PROJECT: TROPICAL DURANGO PARK - PHASE II

CITY OF LAS VEGAS INTER-OFFICE MEMORANDUM			DATE: March 16, 2011	
TO: Land Development Services Department of Public Works			FROM: Albert Sung, P.E. Flood Control Project Engineer Department of Public Works	
SUBJECT: Drainage Study for: Tropical Durango Park – Phase II			COPIES TO: Stanley Consultants	
Cross Streets:		NWC of Tropical Pkwy. & Durango Drive		Architectural Services, Patrick Batte City of Las Vegas
File Number:		F:\Depot\DSMemos\DS4517B.doc		Bart Anderson, P.E., DevCo
Parcel Number:		125-29-601-021		CCPW
Zoning Action:		SDR-39771		
FEMA Flood Zone		YES	NO	X
Proposed Storm Drain		YES	X	NO

TECHNICAL DRAINAGE STUDY UPDATE, ADDENDUM 1 for TROPICAL DURANGO PARK: PHASE II

Subject: Technical Drainage Study Update, Addendum 1, for Tropical / Durango Park Phase II, City of Las Vegas File Number DS4517A.

Cross Section for Update-Sect W (B) Tropical - pre-berm

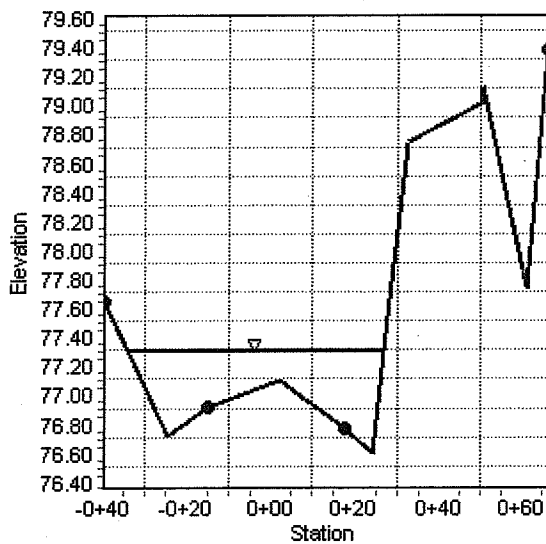
b) The 100-year normal depth in Section W (B) in the existing condition is shown to be 1.74' which is hugely different from the other two sections. Correct in the next submittal.

The section was copied from the approved study; however, it appears that the section had incorrectly included a 75.5 ft elevation point on the north side of the road. The section was revised and the new calculation is included. The normal depth decreased to 0.7 ft. Because the error affected only a very small part of the overall cross sectional area, the water surface

elevation, 77.3 ft, did not change, and thus, the proposed improvements to Tropical will, as shown in original submittal, decrease the water surface elevation at this location.

Cross Section for V-Notch Weir - Sidewalk @ SW corner of Park

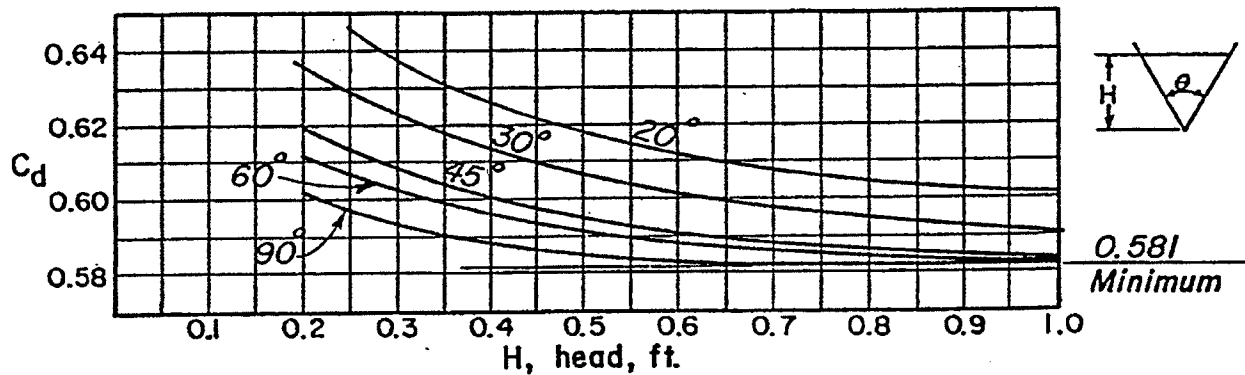
d) Address what the straight line running from "87.OFG/HP" to "74.4OFG" is? According to the contour lines, this line appears to be a flow line in the upper half but turns to a ridge line in the lower half. A culvert is required if this line indeed discharges at the sidewalk confluence. Address and resolve in the next submittal.

The line was removed from the plan. It was included in Phase 1 to describe to the contractor how the grass area should be sloped. The grading for this area was completed with Phase 1 construction, and the slopes of the grass area are now shown as existing contours. The grass area is basically flat and stormwater from minor events is expected to infiltrate into the soil.

During the 100-year storm event, flow will weir over the sidewalk. The flow from the 100-year event is 6 cfs (referenced from the Ultimate Condition of the approved study for Phase 1, sub-basin C-PARK). The sidewalk is essentially a v-notch weir with an angle less than 175 degrees. The depth of flow is less than 0.5 ft; velocity is less than 2 ft/sec; thus, depth times velocity is well below the 6 ft²/s minimum allowed. Therefore, neither a culvert nor sidewalk underdrain is required.
